Addendum #1

Project Name:	LBE Project No.:	Date Issued:
City of Kenora North Hamilton Lift Station Piping	23070	July 16, 2024
Replacement

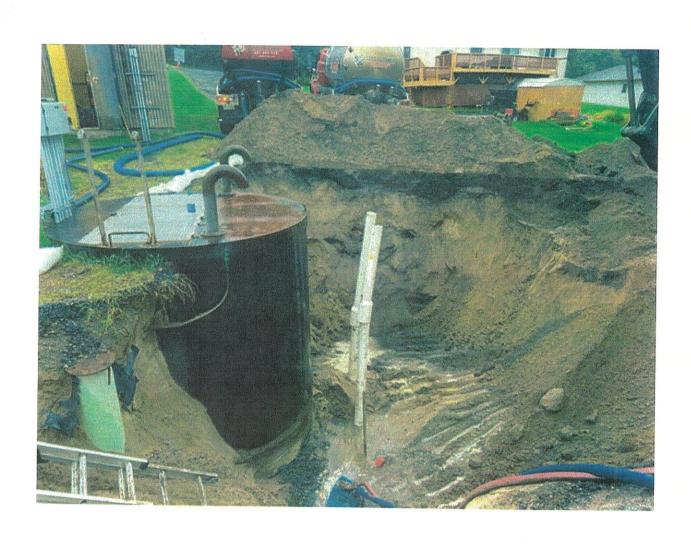
Question:	Confirm pump P-2 is to be removed and not reinstalled, leaving the station with two pumps rather than three pumps upon completion.	
2	Response:	Pump P-2 is currently not installed in the lift station. Pumps P-1 and P-3 shall be removed for the duration of work and reinstalled upon completion. The replacement of the piping and pump base for the future installation of pump P-2 shall be included in the scope.	
3	Question:	During the site visit, the City noted they have some photos from other work at this station, can these photos be provided?

Response:	Please see enclosed photos of previous works.	
4	Question:	During the site visit, the City noted they would pump out the existing chamber for the contractor upon commencement of the work. Can this be confirmed in writing?
